Ref. No.	Issuer company	Issue (yyyy/mm/dd)	Last modification (yyyy/mm/dd)
PV13HDR513	Digital Imaging group	2013/07/04	
Subject			
Compatibility between P_Cabinet_M and Ground_Plate_P			
Model (System model)	Destination	Serial number	Color
HDR-PJ260 / E / V / VE	All	All	
HDR-PJ580 / E / V / VE	All	All	
HDR-PJ590V	All	All	
HDR-PJ600E / V / VE	All	All

SYMPTOM

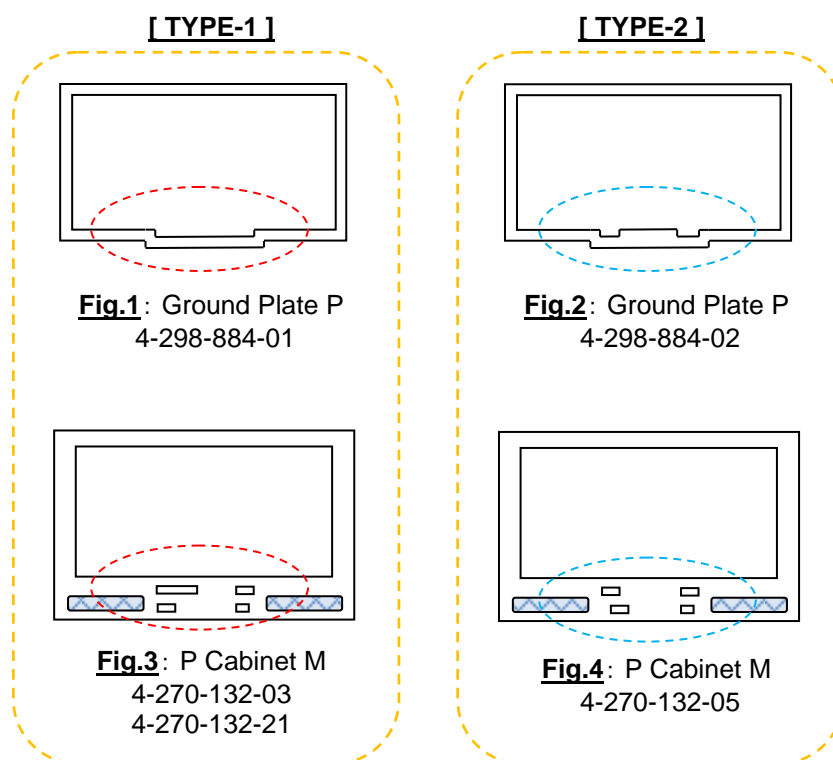
The compatibility of the shapes needs to be considered for the combination of [Ground_Plate_P] and [P_Cabinet_M]. If either of these parts needs to be replaced, please check the following [Combination Table].

- 1) Ground Plate P: 4-298-884-01 (Fig.1)
- 2) Ground Plate P: 4-298-884-02 (Fig.2)
- 3) P Cabinet M: 4-270-132-03 (Fig.3) : for HDR-PJ580 series, HDR-PJ590V, HDR-PJ600 series.
- 4) P Cabinet M: 4-270-132-05 (Fig.4) : for HDR-PJ580 series, HDR-PJ590V, HDR-PJ600 series.
- 5) P Cabinet M: 4-270-132-21 (Fig.3) : for HDR-PJ260 series

If either of the parts needs to be replaced, please check the following [Combination Table] and replace the part accordingly.

When replacing Ground_Plate_P (-02) type or replacing P_Cabinet_M of [TYPE-2] by HDR-PJ260series, Replace to both part [TYPE-1].

=>replace to both Ground_Plate_P(-01) & P_Cabinet_M(-21) same time.
